**Economic Commission for Europe****Inland Transport Committee****World Forum for Harmonization of Vehicle Regulations****Working Party on Lighting and Light-Signalling****Eighty-second session**

**Simplification of lighting and light-signalling UN Regulations****Proposal for Supplements to the new UN Regulation  
No. [148] and to the 06 and [07] series of amendments to UN  
Regulation No. 48****Submitted by the expert from Germany\***

Figure 1

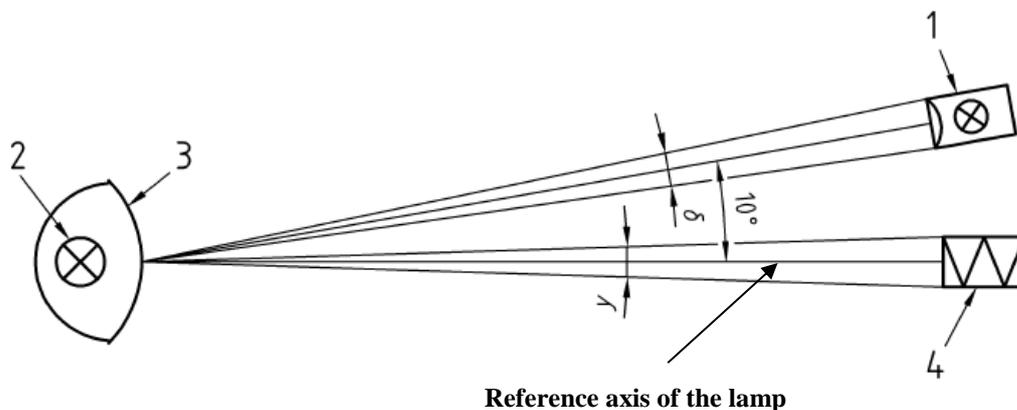
The light source generating a sun load impact according to Figure 1 below is a projector either with a light source of a correlated colour temperature between 4500 K and 6500K or with a light source of a correlated colour temperature at 2856 K corresponding to the CIE Standard Illuminant A (ISO 11664-2:2007(E)/CIE S 014-2/E:2006).

The reference axis of the lamp and the axis of the projector shall form a vertical angle of  $10^\circ$ .

The plane formed from both axes shall be the operational vertical plane. The arrangement shall be in a way that the projector radiates the light as if from above the signalling lamp.

Measurements of sun load impact (phantom effect) depends strongly on the geometry of measurement. The recommended distance for measurements for obtaining comparable results is 10m.

The measuring head to determine the luminance shall be placed so that the reference axis of the lamp and the axis of the measuring head coincide.
